AQUALAND

ACCESS DESIGN REVIEW – DEVELOPMENT APPLICATION (DA)

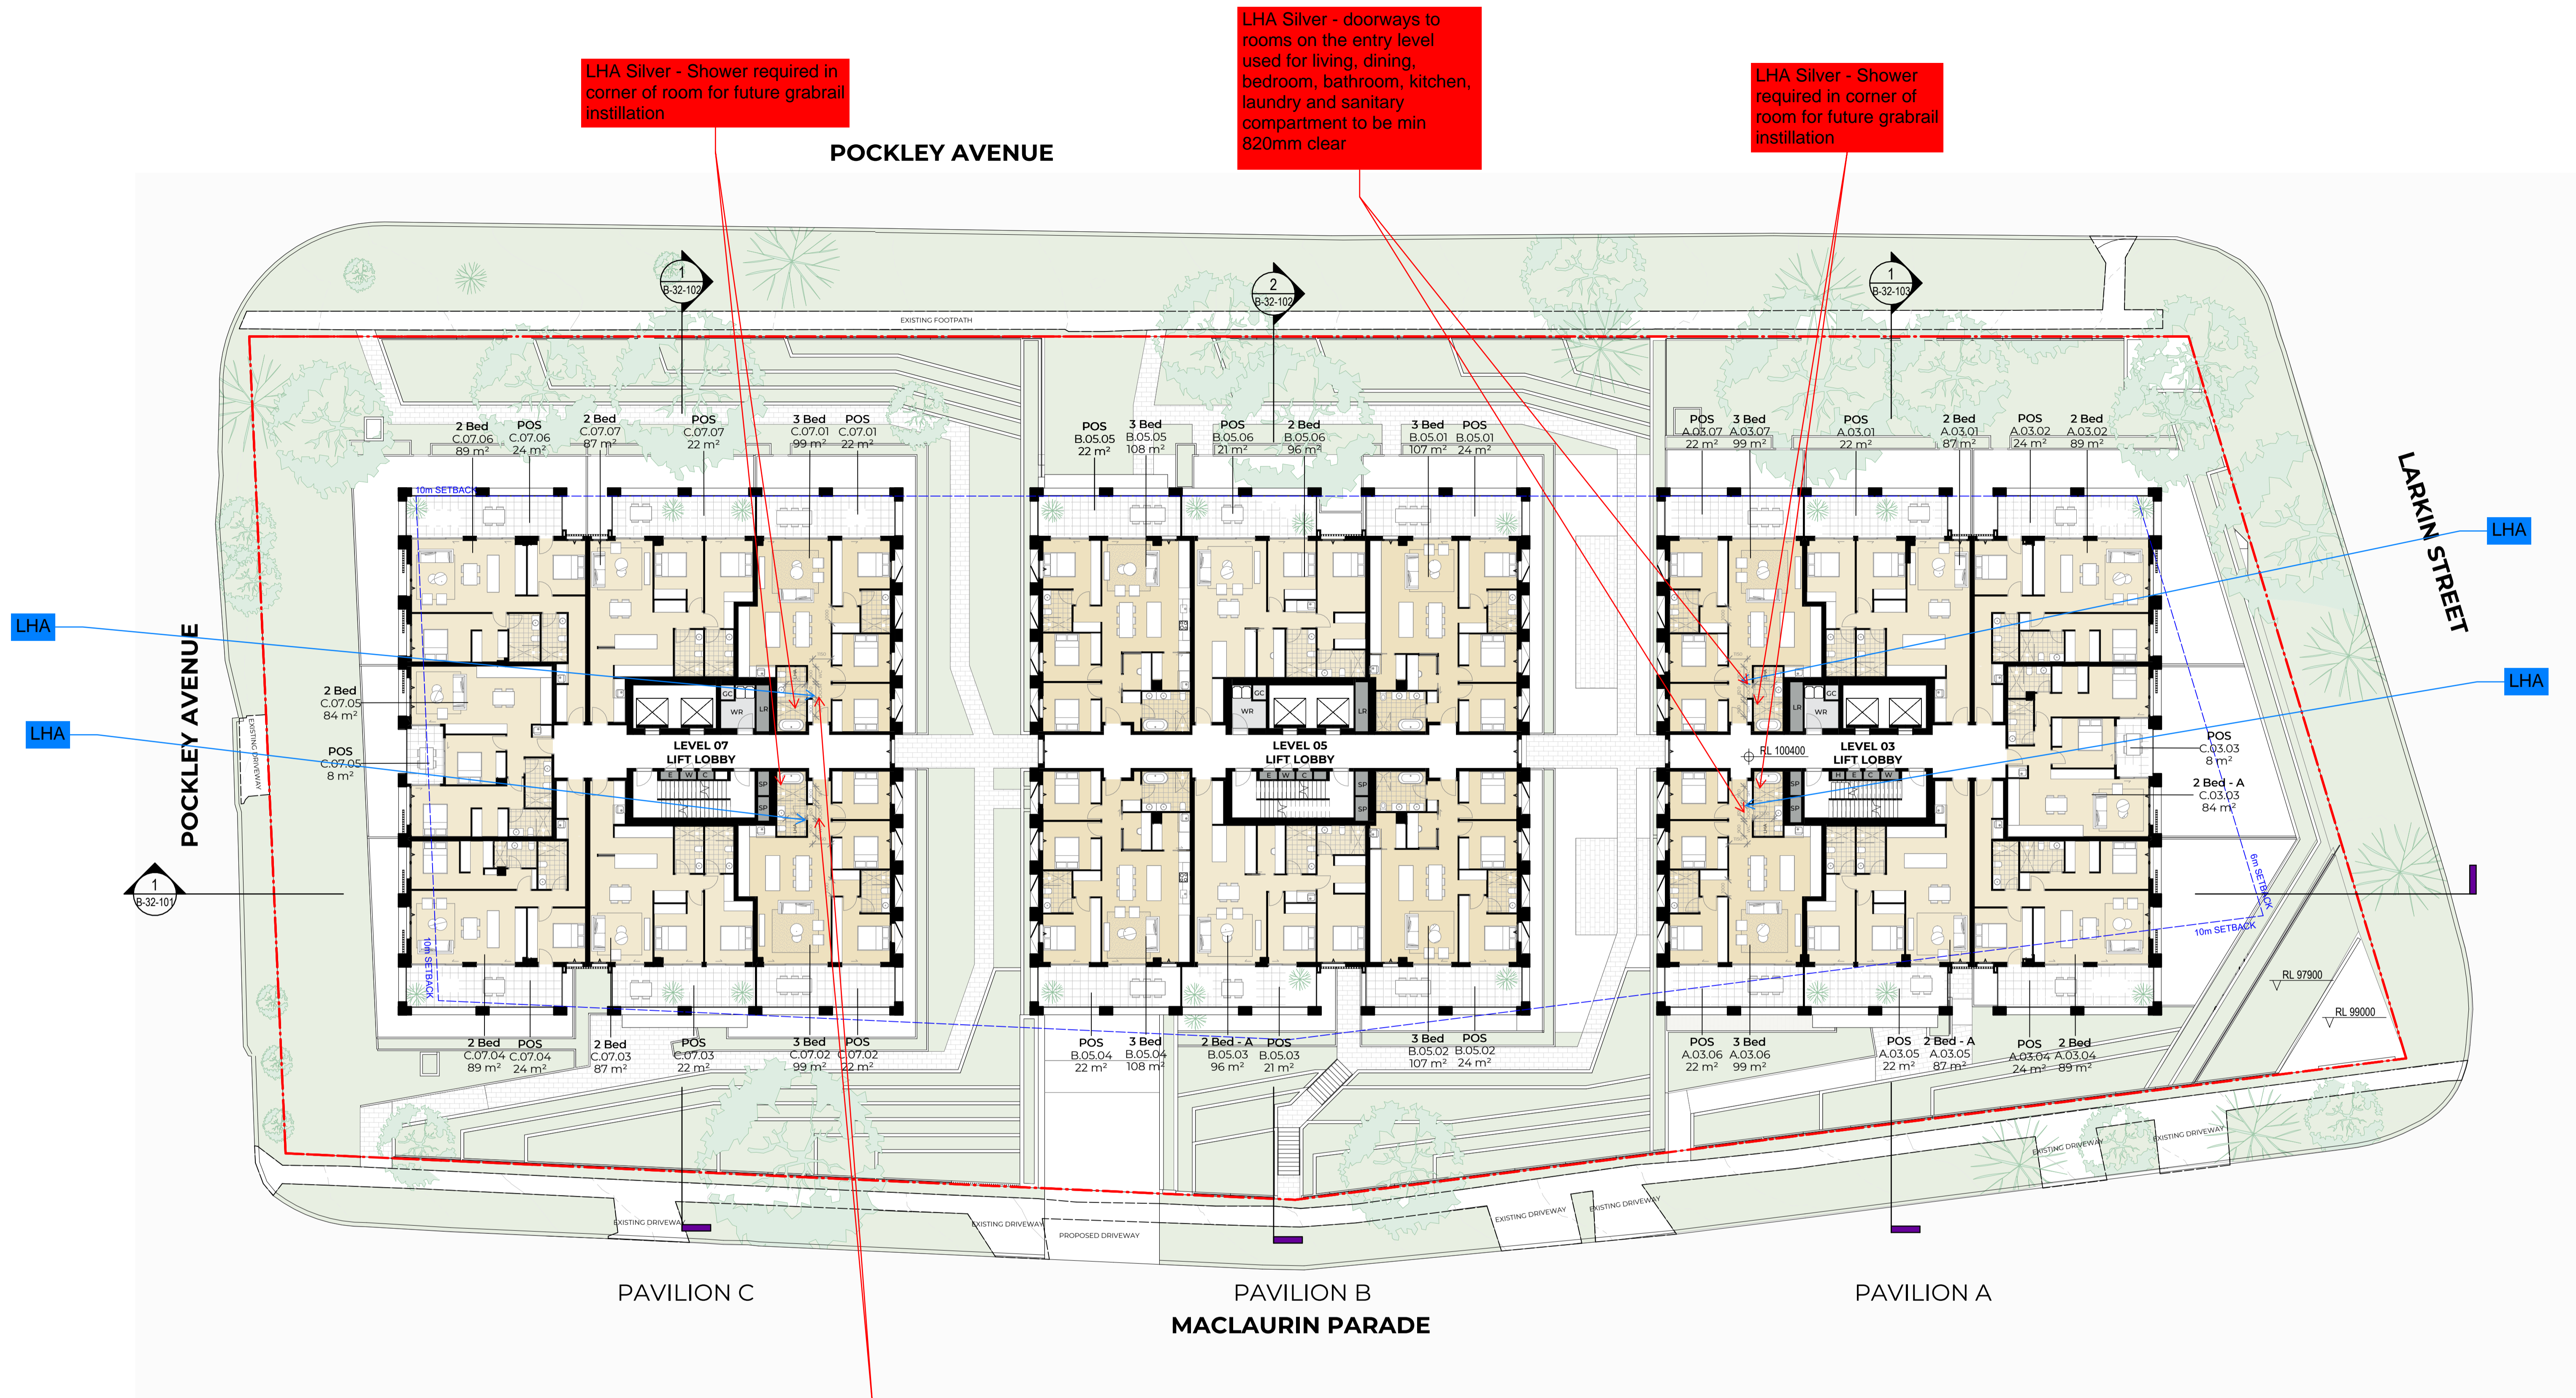
Orange comments relate to questions, clarifications and considerations moving forward
 Red comments relate to elements requiring adjustment

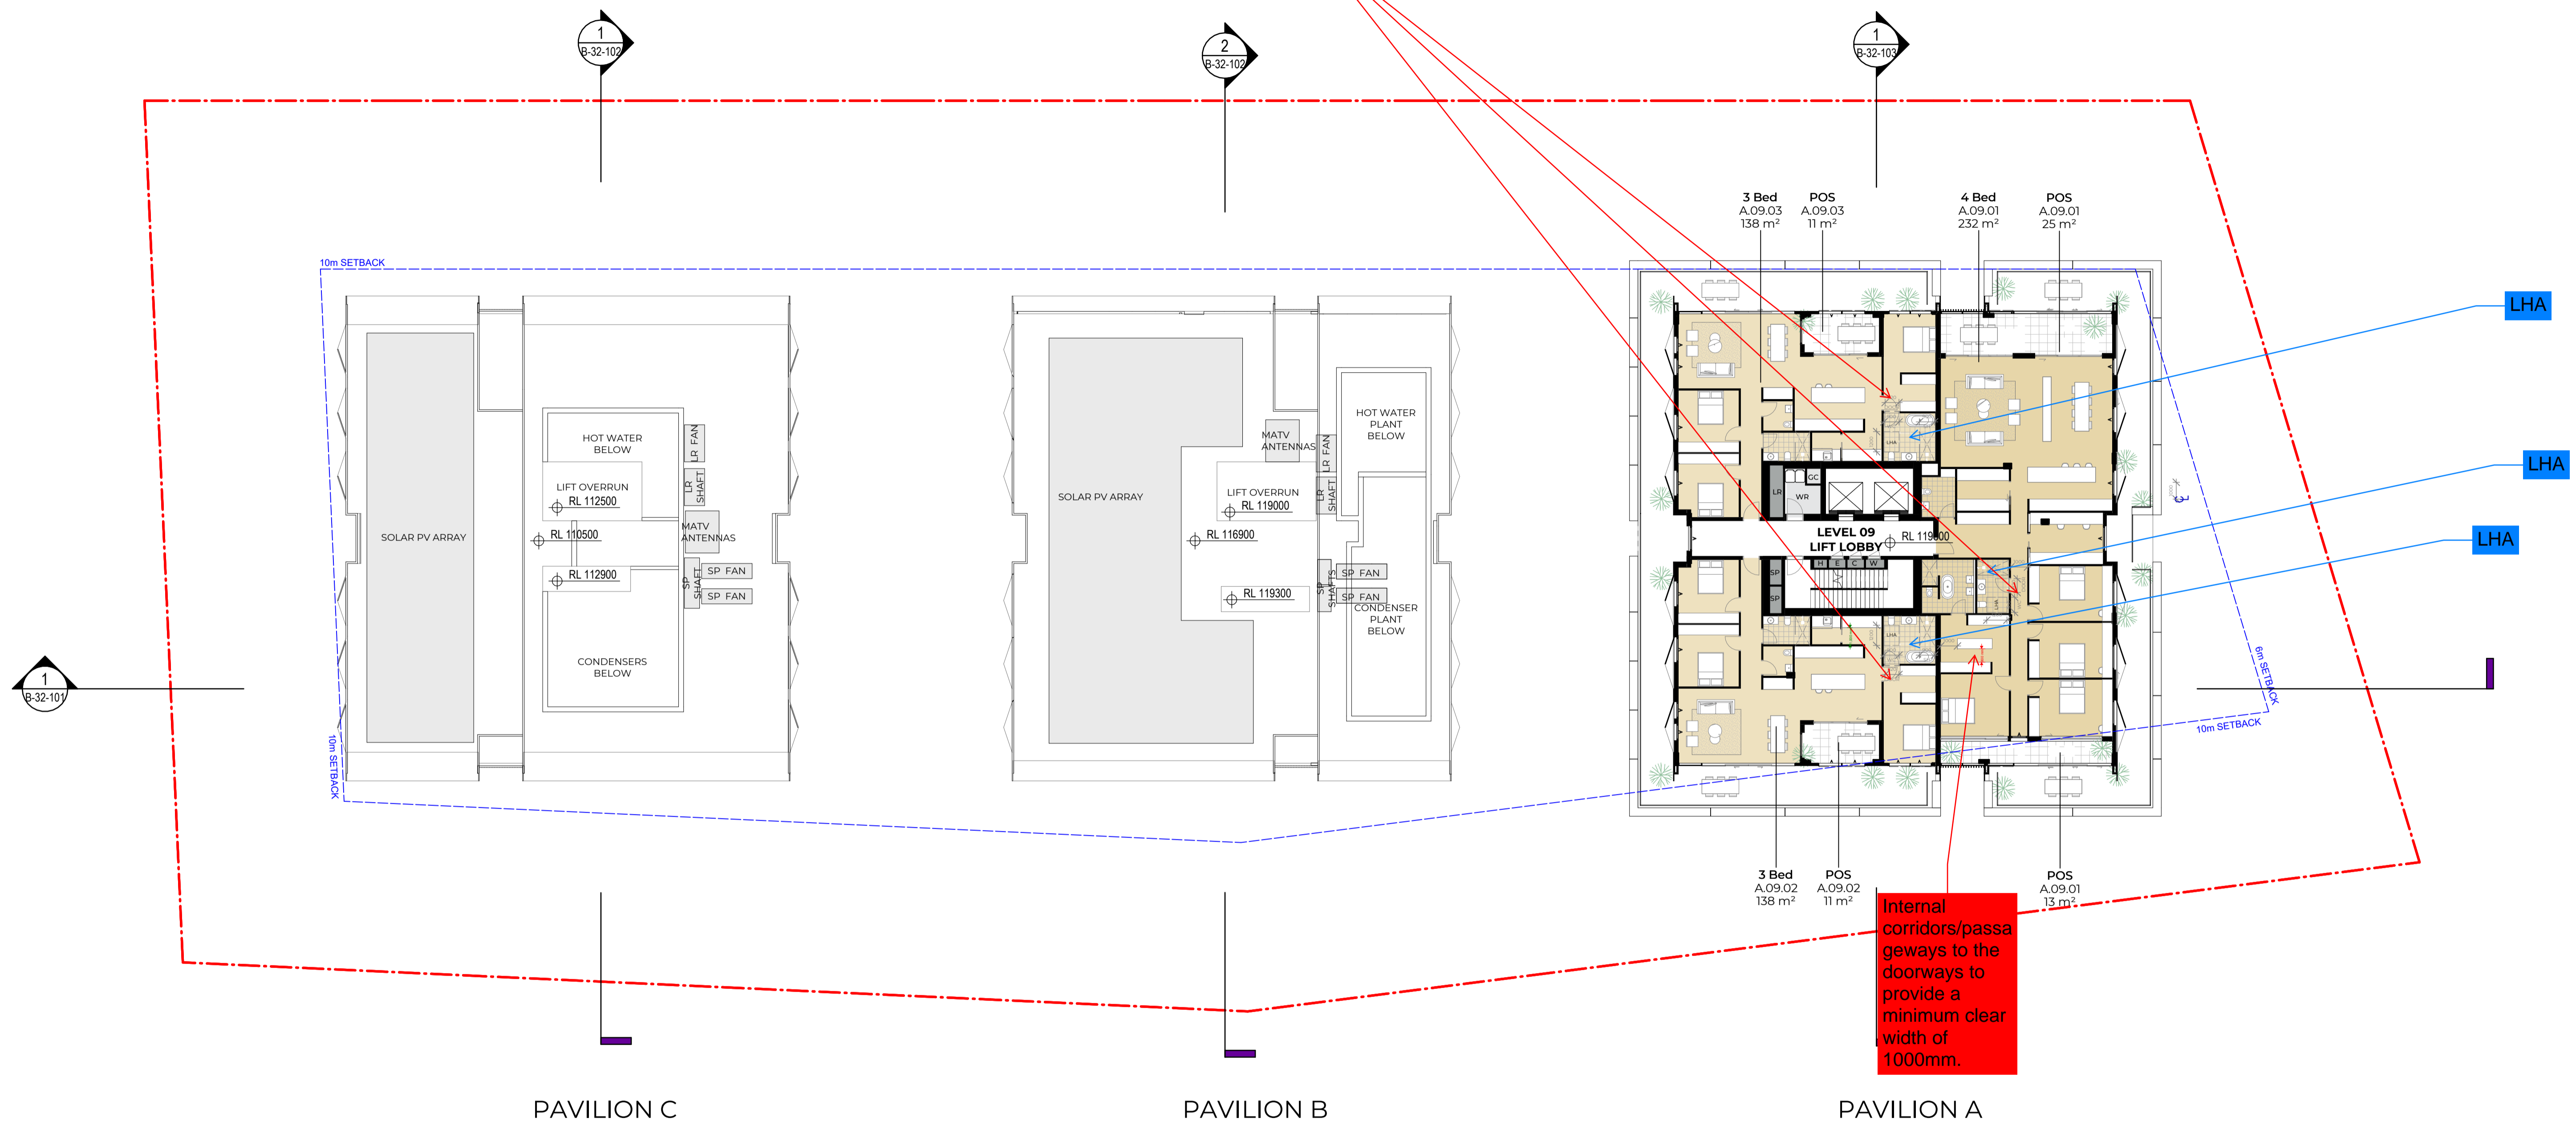
Orange comments relate to questions, clarifications and considerations moving forward
 Red comments relate to elements requiring adjustment

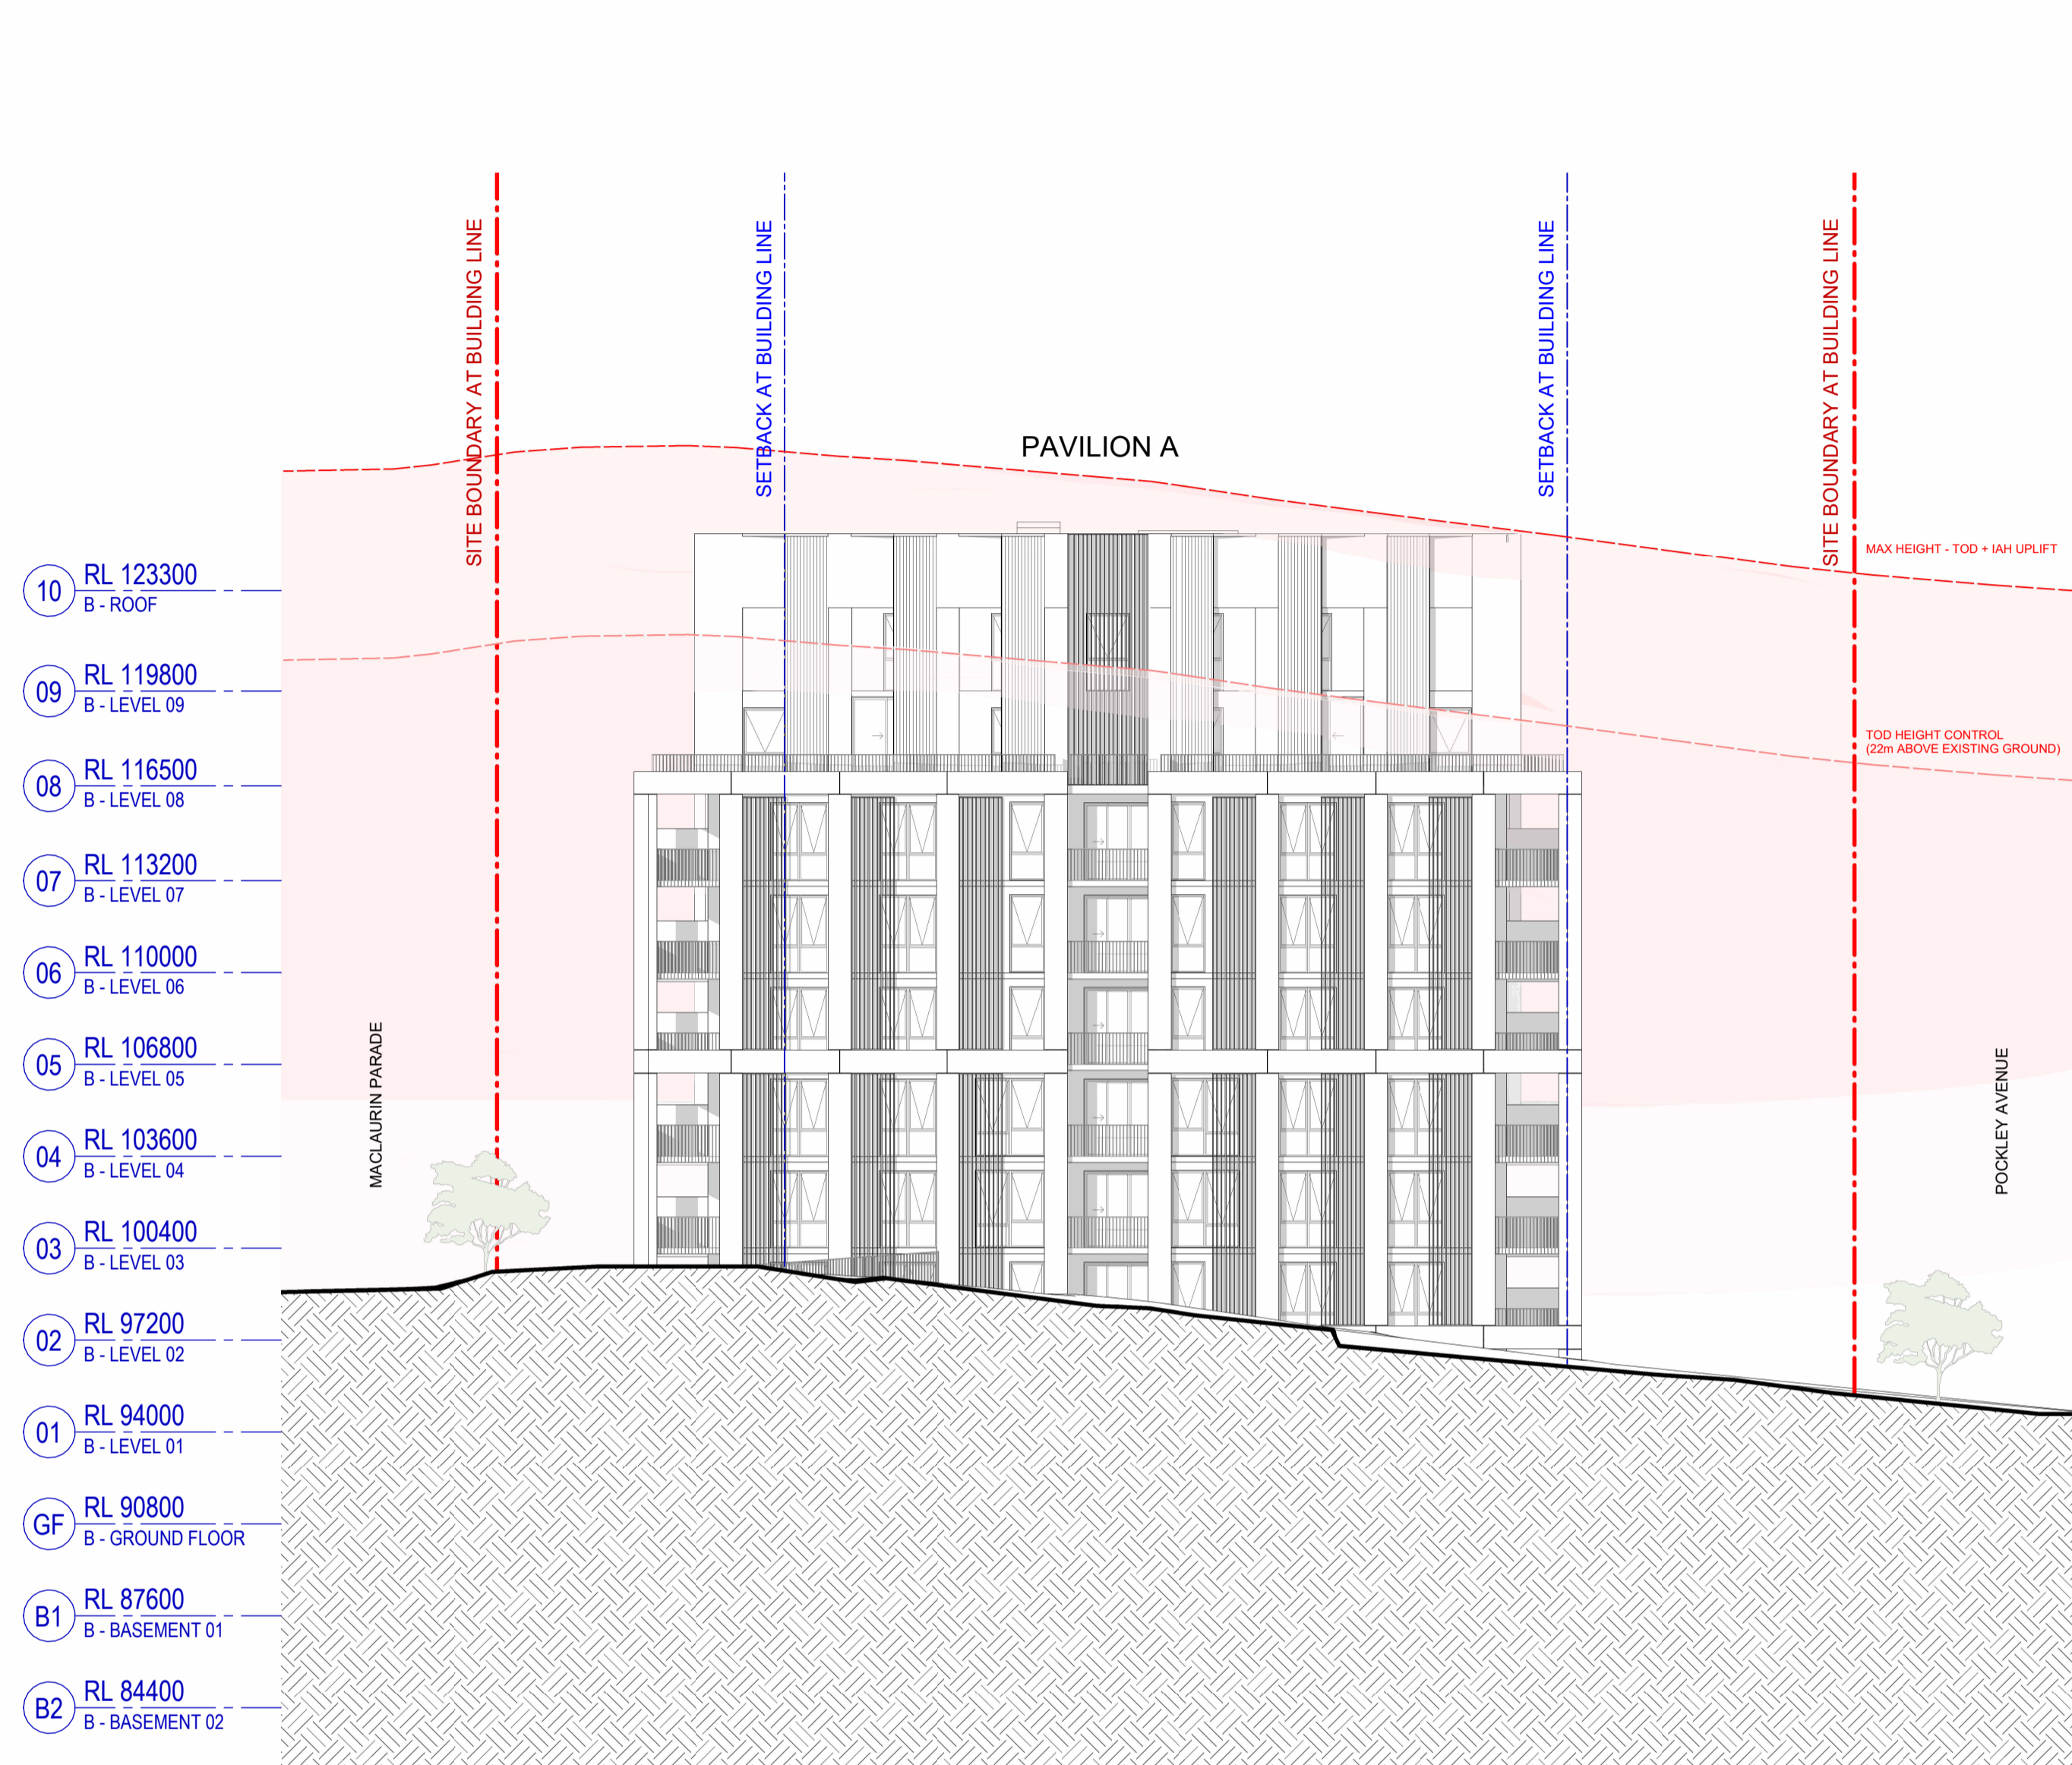
Orange comments relate to questions, clarifications and considerations moving forward
 Red comments relate to elements requiring adjustment
